RE: GM - Saginaw Site (# 915152)
City of Buffalo, Erie County

Evaluation of the Former GM – Saginaw Facility Investigations

**Project B4295
December 22, 1997**

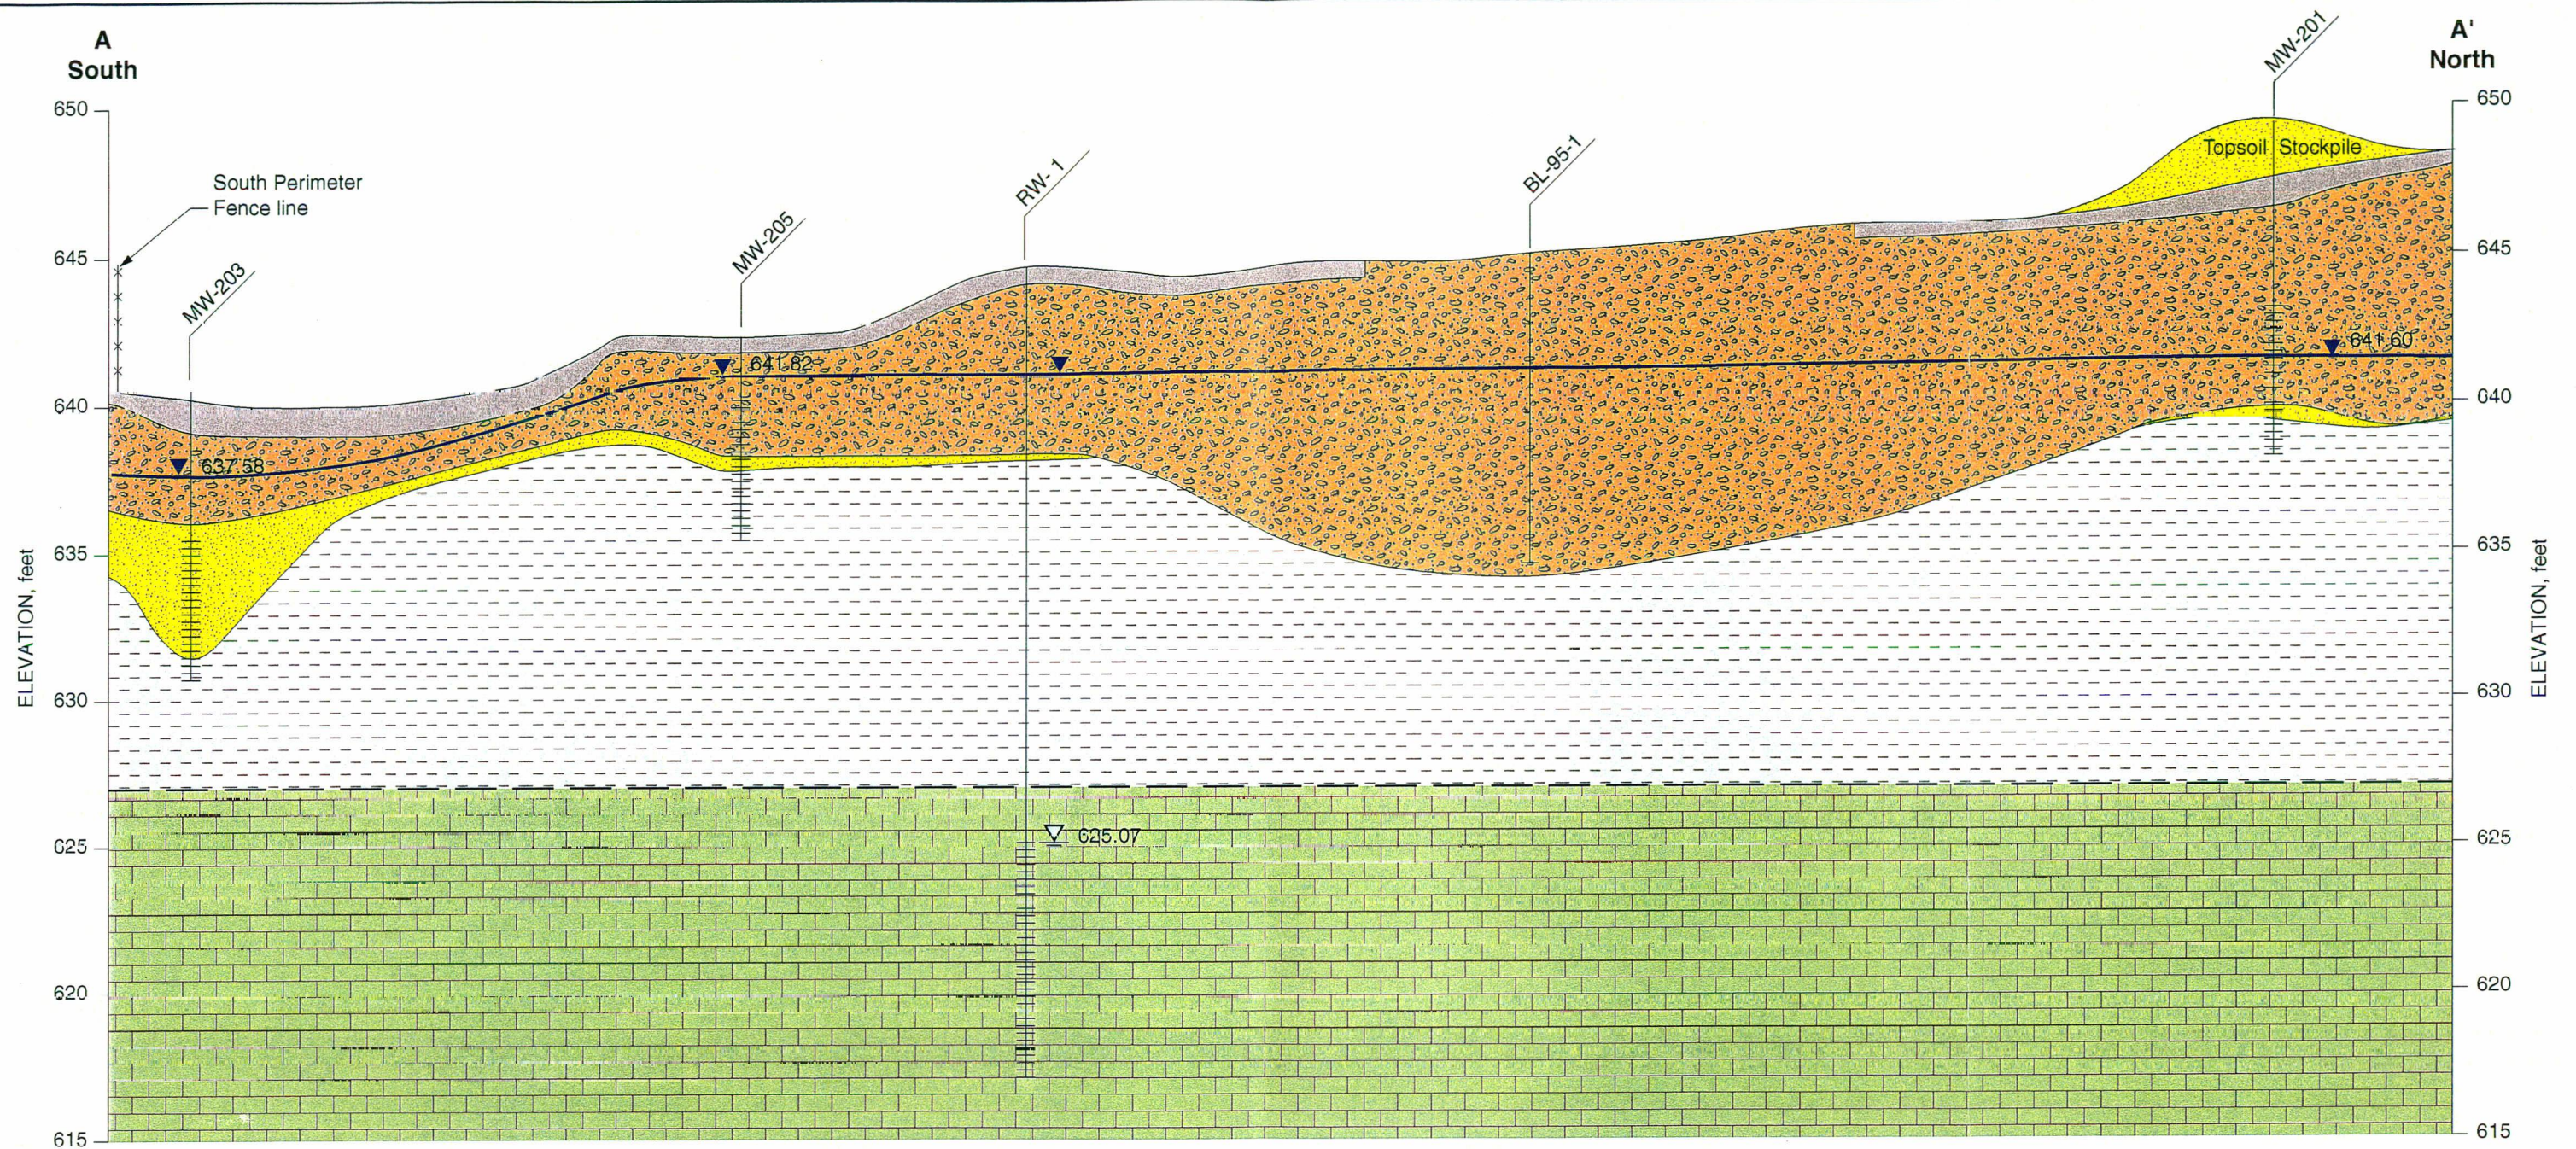
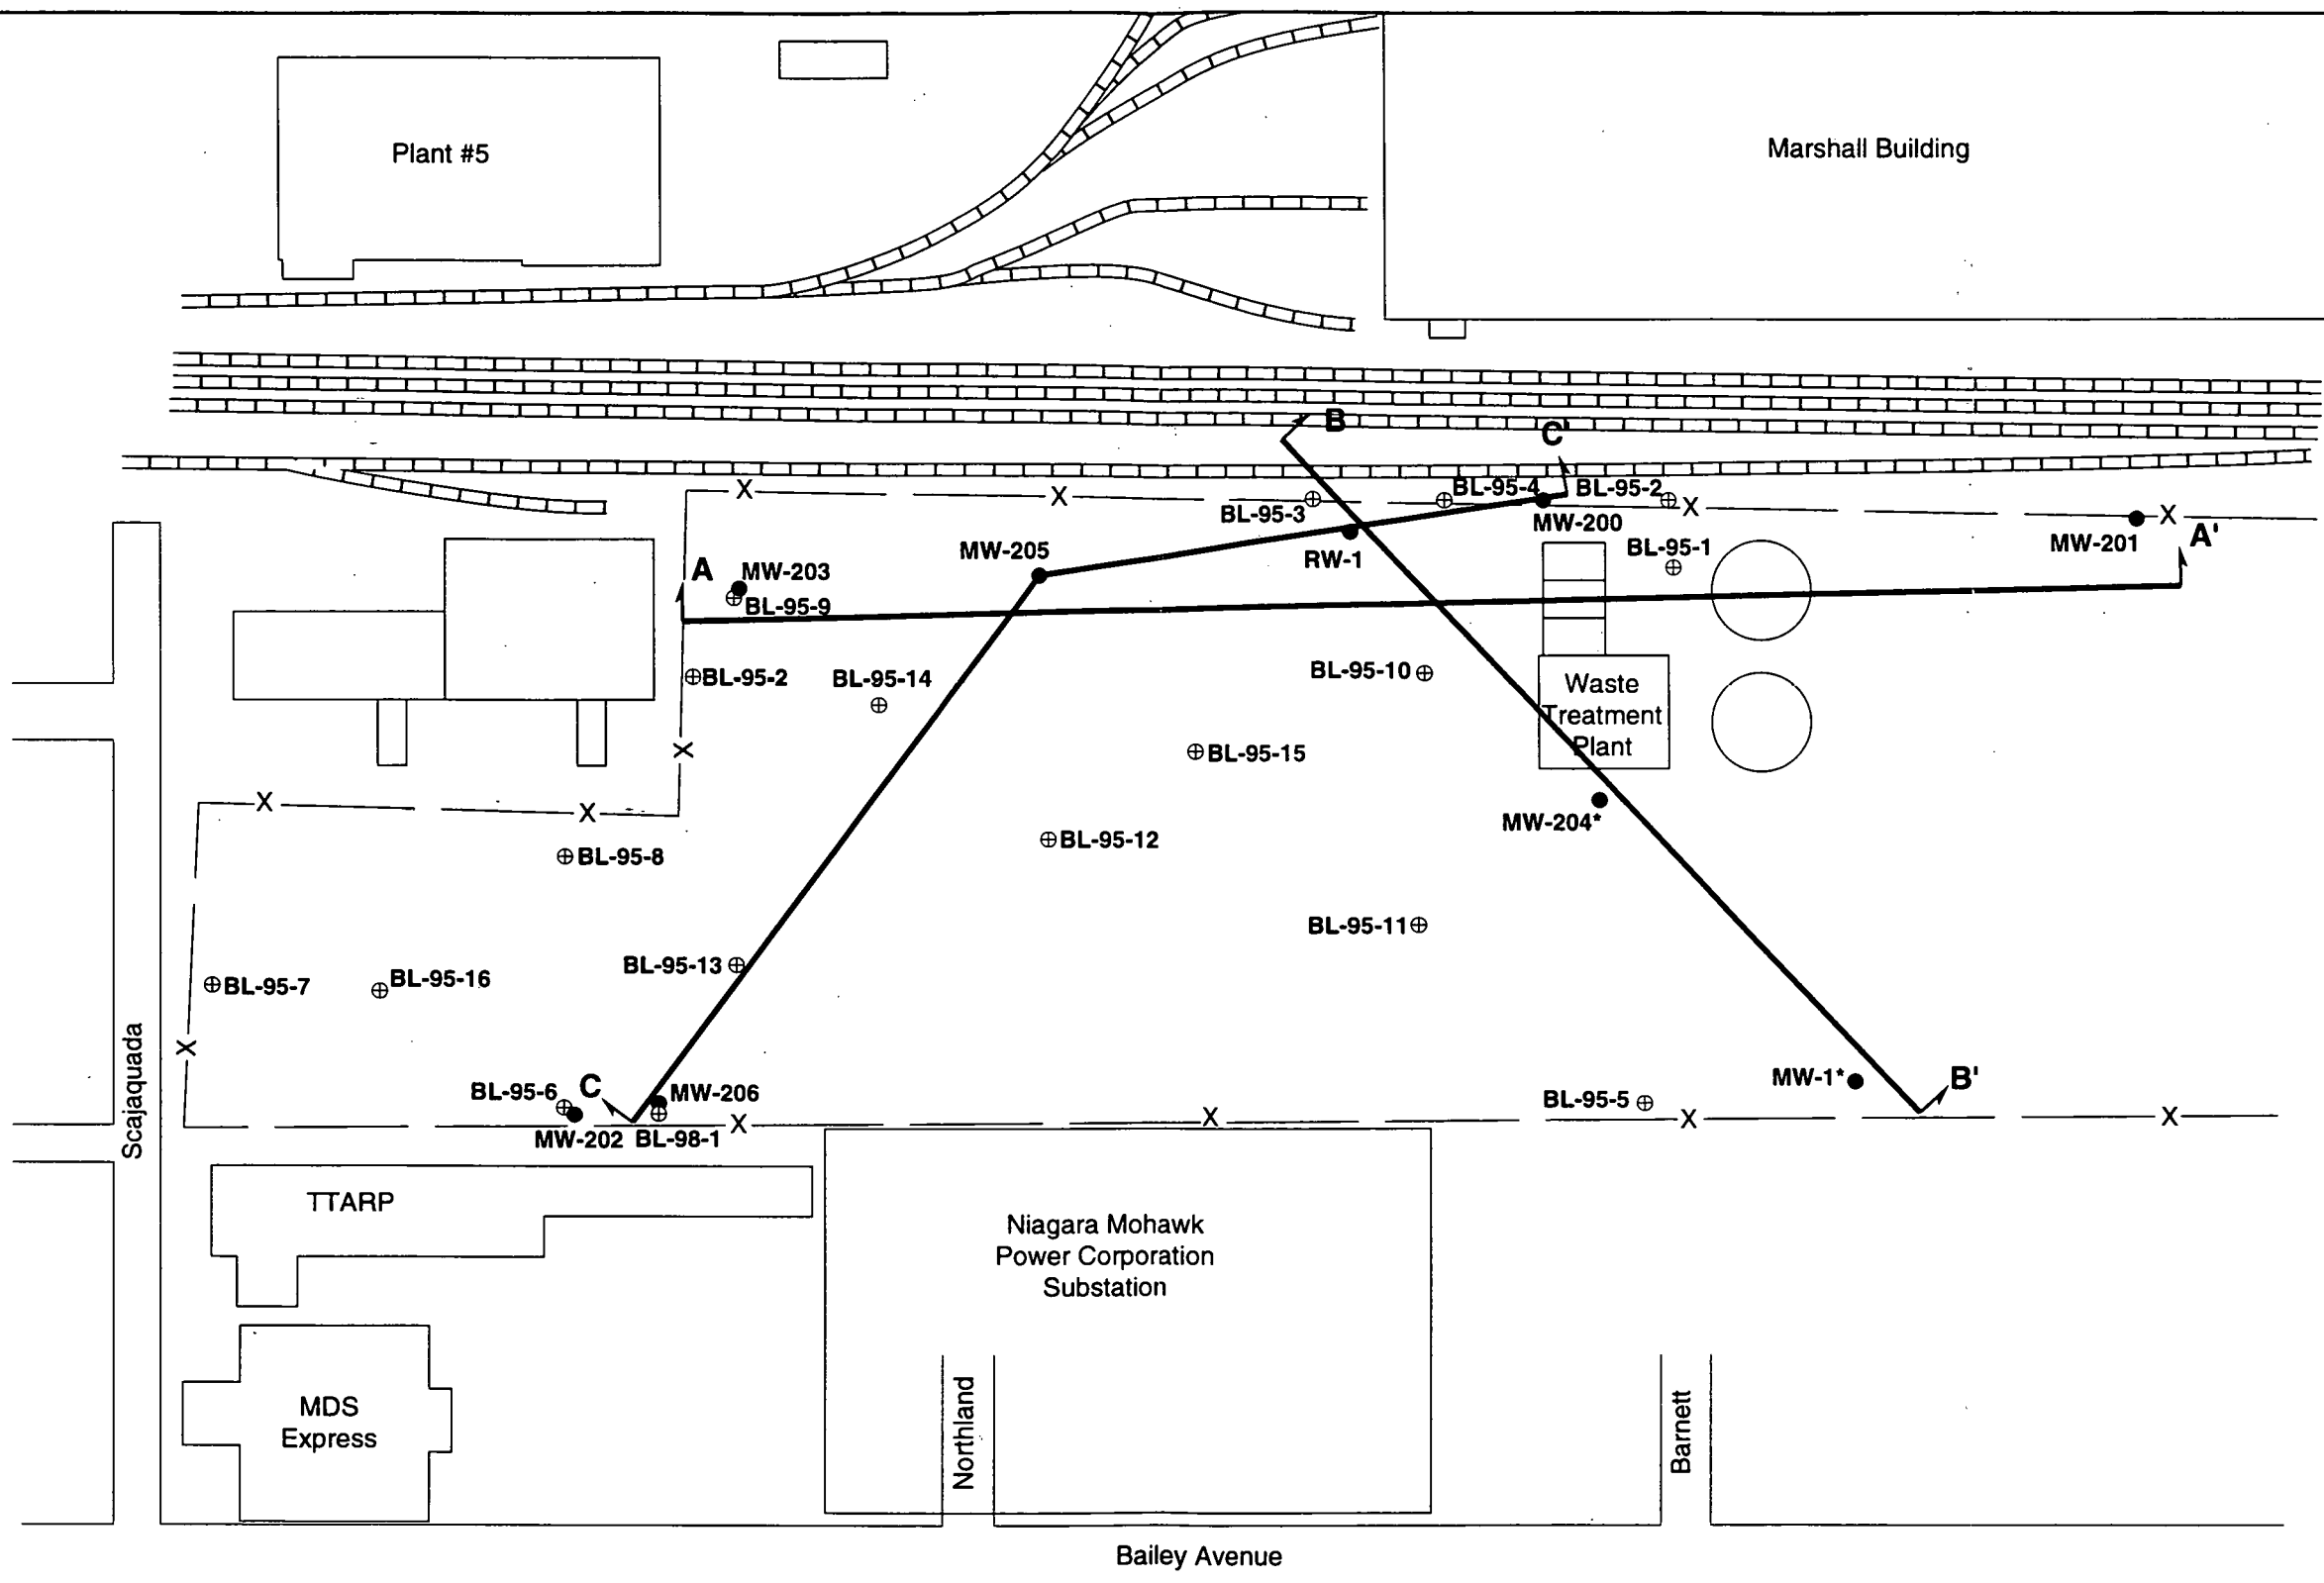
These stratigraphic units are presented in cross-section using the same section lines drawn by EMCON (Drawings 4 and 5 of the Site Investigation Report) on Figures 2 and 3. However, several corrections to the EMCON-prepared cross-sections were necessary to match monitoring well construction diagrams (i.e. well screen positions) and location of geologic contacts to depths reported in the borehole logs. An additional cross-section was prepared using EMCON data along section line C-C', oriented with the general direction of groundwater flow (see Figure 4). Since storm sewer depths are not presented in the EMCON report, sewers are not shown on the cross-sections. The cross-section in Figure 4 shows a clay confining unit sloping from the source area to the southeast toward the southwest corner of NMPC property.
